Access Compliance Report

Public Rights-of-Way (Curb Ramps)

Intersection ID: 24329	Main Street: GARBOW_CT	Cross Street: MIROW_PL	Location: S
ADA ID: 9B7876058CE0	Ramp Type: PerpDiag	Initial Pass/Fail: Fail	Overall Compliance: No
		Severity Score: 25

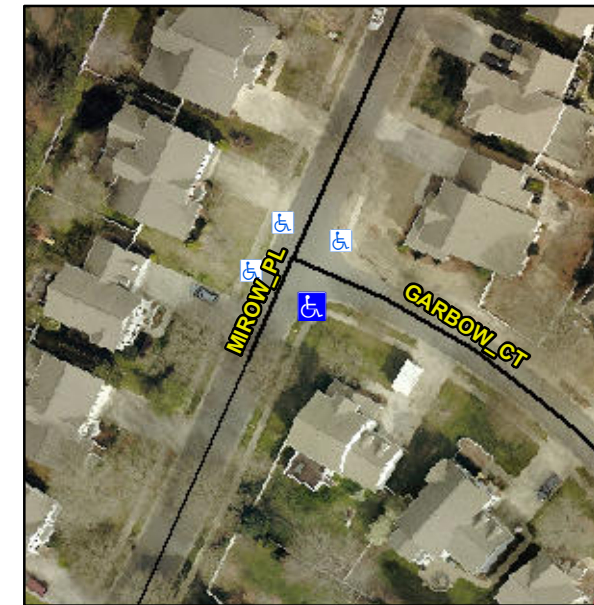
Not Found, R304.2.2, R304.5.3

Compliance	Description	Data	Compliance	Description	Data
N/A	Ramp Length (in)	37.0	No	Ramp Slope (%)	8.4
Yes	Ramp Width (in)	48.0	No	Ramp XSlope (%)	5.4
N/A	Flare Type LT	N/A	N/A	Flare Type RT	N/A
N/A	Flare Slope LT (%)	N/A	N/A	Flare Slope RT (%)	N/A
N/A	Flare Traversable LT?	N/A	N/A	Flare Traversable RT?	N/A
N/A	Landing Length (in)	N/A	N/A	DWS Provided?	N/A
N/A	Landing Width (in)	N/A	N/A	DWS Contrast?	N/A
N/A	Landing Slope (%)	N/A	N/A	DWS Length (in)	N/A
N/A	Landing X Slope (%)	N/A	N/A	DWS Full Width?	N/A
N/A	Landing Curb? (Y/N)	N/A	N/A	DWS Offset (in)	N/A
N/A	Shared Landing?	N/A			
N/A	Gutter Ponding?	N/A	N/A	Gutter Slope (%)	N/A
N/A	Gutter Lip Ht (in)	N/A	N/A	Gutter X Slope (%)	N/A
N/A	Painted X Walk1?	No	N/A	Painted X Walk2?	No
	X Walk 1 Direction	To NE		X Walk 2 Direction	To NW
N/A	X Walk 1 Width (in)	N/A	N/A	X Walk 2 Width (in)	N/A
	X Walk 1 Slope (%)	5.5		X Walk 2 Slope (%)	1.2
	X Walk 1 X Slope (%)	1.5		X Walk 2 X Slope (%)	4.0

Remove & Replace Curb Ramp With Two New Directional Ramps or Equivalent.
